SUBJECT: Initial Draft of **MIL-PRF-55681H and Supplement 1** (Capacitor, Chip, Multiple Layer, Fixed Ceramic Dielectric, Established Reliability and Non-Established Reliability, General Specification for).

Project number: 5910-2025-008.

NOTE: This draft, dated 14 January 2025, prepared by DLA-CC, has not been approved and is subject to modification.
DO NOT USE PRIOR TO APPROVAL. (Project 5910-2025-008)

FIGURE 3. Board flex.

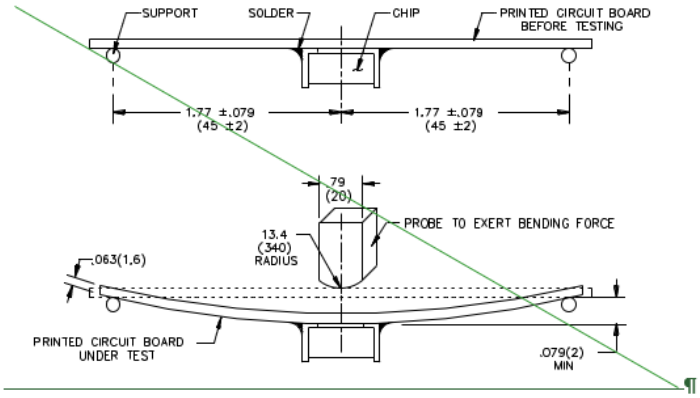
- Update board flex and shear stress testing to be in accordance with MIL-STD-202-218 and -219 respectively.
- Add "Intended assembly methods for surface mount capacitors" paragraph to section 6.

b. Procedure: The FR4 PCB shall be placed into a fixture similar to the one shown in figure 3 with the component facing down. A force shall be applied which will bend the board .079 inch (2.0 mm), minimum.

FIGURE 4. Shear stress.

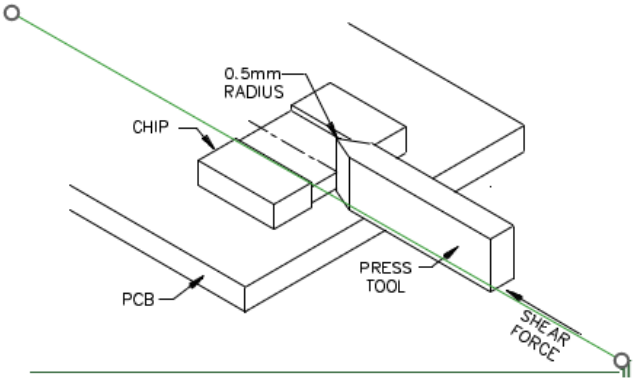
4.8.18.1.2 Shear stress test (see 3.21.1.2). Capacitors shall be tested for shear stress in accordance with MIL-STD-202-219.the following:
